**SUBJECT:** Savannah River Site's Responses to the Regulatory Comments on the K-Area Burning/Rubble Pit and Rubble Pile (131-K and 631-20G) (KBRP) and P-Area Burning/Rubble Pit (131-P) (PBRP) Operable Units Detailed Combined Groundwater Monitoring Report (SRNS-RP-2022-00253, Revision 0, June 2022) SEMS Numbers: 40 and 59

**SRS Responses to South Carolina Department of Health and Environmental Control on  
the K-Area Burning/Rubble Pit and Rubble Pile (131-K and 631-20G) (KBRP) and P-Area  
Burning/Rubble Pit (131-P) (PBRP) Operable Units Combined Groundwater Monitoring  
Report, SRNS-RP-2022-00253, Revision 0, June 2022, SEMS Numbers: 40 and 55  
Savannah River Site, South Carolina**

**SRS Responses to Environmental Protection Agency on the K-Area Burning/Rubble Pit and Rubble Pile (131-K and 631-20G) (KBRP) and P-Area Burning/Rubble Pit (131-P) (PBRP) Operable Units Combined Groundwater Monitoring Report, SRNS-RP-2022-00253, Revision 0, June 2022, SEMS Numbers: 40 and 55  
Savannah River Site, South Carolina**

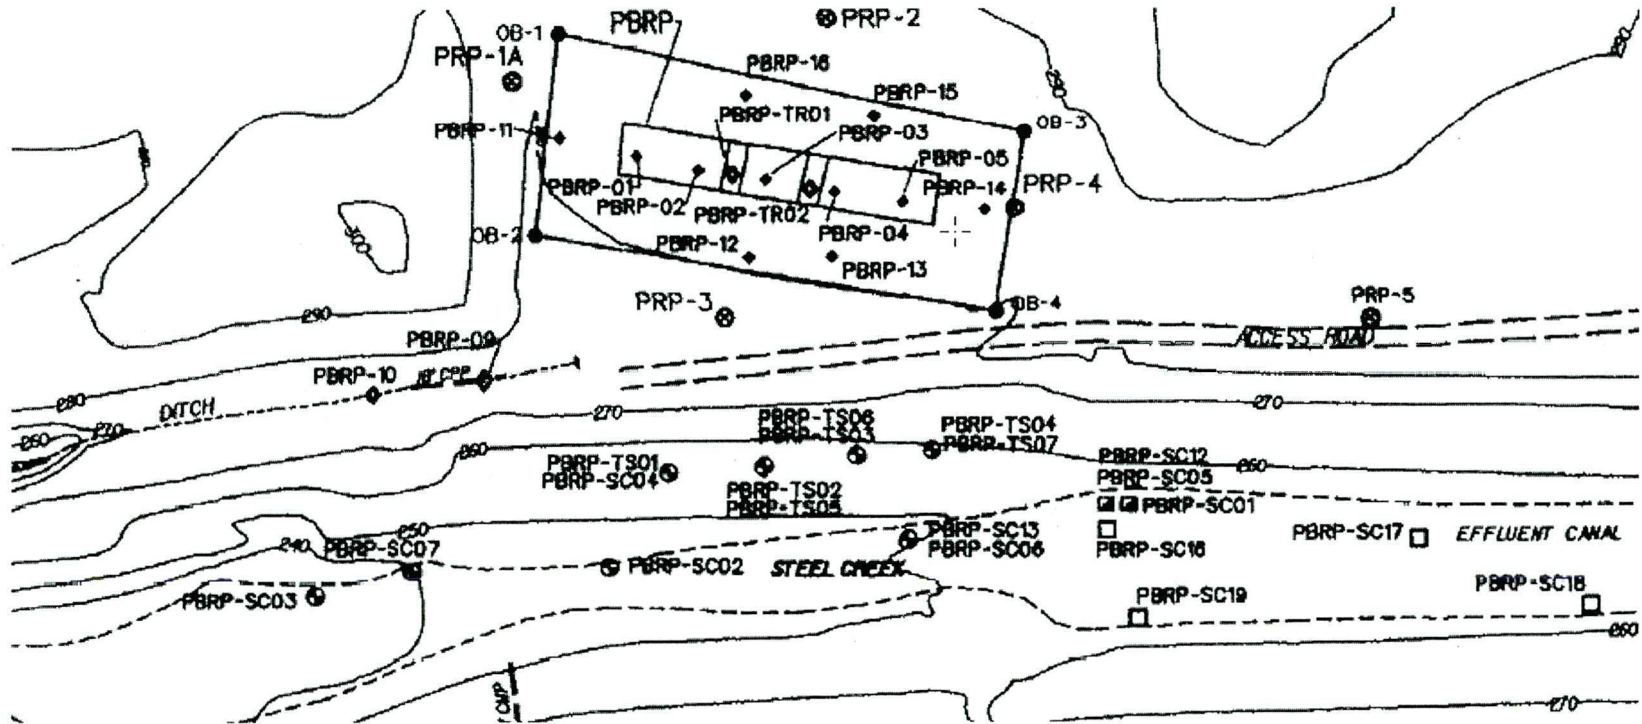
6. **Appendix B, Groundwater and Surface-Water Monitoring Results (2021), Table B-2, 2021 PBRP Monitoring Data, Page B-9 of B-10:** The table contains additional 1,4-dioxane results without explanation for wells PRP 5, PRP 6, and PRP 7. The table lists a second value for 1,4-dioxane, however, no description of this second result is included (e.g., laboratory duplicate, field duplicate). *Please revise the text to include a description of the second 1,4-dioxane result for each well.*

The description of the second result is included in the third paragraph of section 3.2.4. The currently approved method (EPA8260SIM) for analyzing 1,4-dioxane is not capable of achieving a quantitation limit low enough to effectively quantify detections of 1,4-dioxane; therefore, SRS chose to also analyze by method EPA522, which can achieve a quantitation limit below the Regional Screening Limit (RSL). This method is for information only; the approved method was also run. In future reports the table will include a footnote to indicate that a separate method was also used.

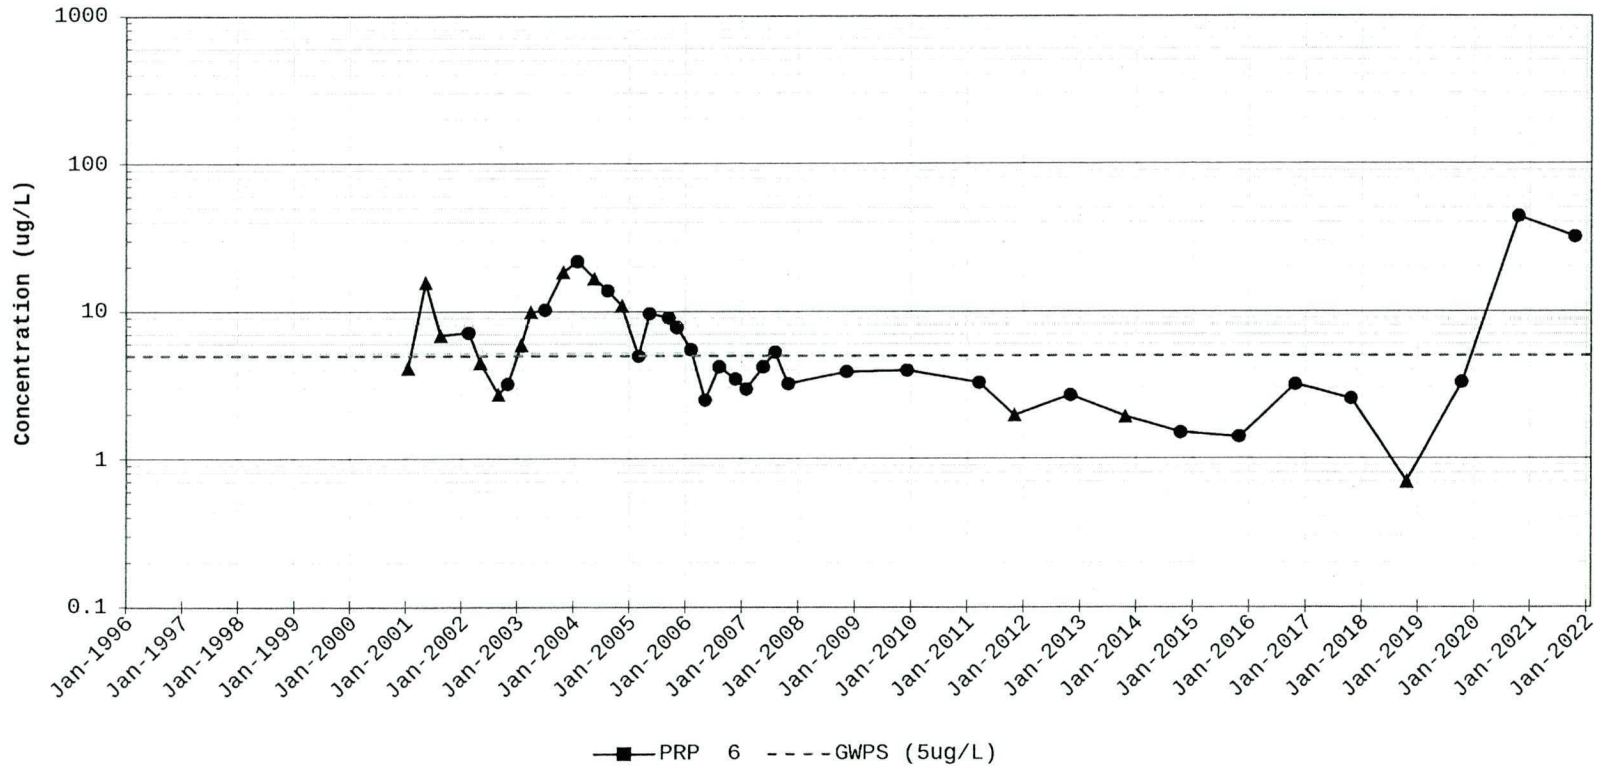
1. It is unclear whether trichloroethylene (TCE) is being sufficiently monitored at surface-water stations in the P-Area Burning/Rubble Pits Operable Unit (PBRP OU). For example, Section 3.2.5 (Lateral and Vertical Extent of Contamination at the PBRP OU) states that “SRS believes that any impact to Steel Creek from the PBRP OU is insignificant, as evidenced by years of no detections of 1,1-DCE within Steel Creek” and Table 5 (Steel Creek Surface-Water Station Data) is referenced for results of 1,1-dichloroethylene (DCE) at surface-water stations SC-02, SC-03 and SC-04. Additionally, Section 3.2.1 (PBRP OU Background) states “Groundwater was determined to be contaminated with 1,1-DCE and TCE only in the area adjacent to the south side of the PBRP and not farther south towards Steel Creek.” However, this statement contradicts the text in Section 3.2.5 (Lateral and Vertical Extent of Contamination at the PBRP OU) which states, “Surface-water station SC-03 has traditionally exhibited elevated levels of TCE and is currently the primary area where the PAGW OU [P-Area Groundwater Operable Unit] VOC [volatile organic compound] plume is discharging.” Therefore, as TCE concentrations appear to be increasing at monitoring well PRP 6, and the water table aquifer discharges to Steel Creek, downstream surface-water stations should be monitored. *Please revise the text to indicate whether TCE is currently being monitored at surface-water stations and if so, include available historical data in the Report as an additional line of evidence to support no surface-water impacts.*

**Historical data from the RCRA Facility Investigation/Remedial Investigation/Baseline Risk Assessment (RFI/RI/BRA) for the P-Area Burning Rubble Pit, WSRC-RP-98-4174, Revision 1.1, April 2001, indicated that impacts to Steel Creek were from upgradient sources and therefore impacts to Steel Creek from the PBRP OU were negligible. The 1998 surface water data and sampling locations from the RFI/RI/BRA are attached at the end of this document.**
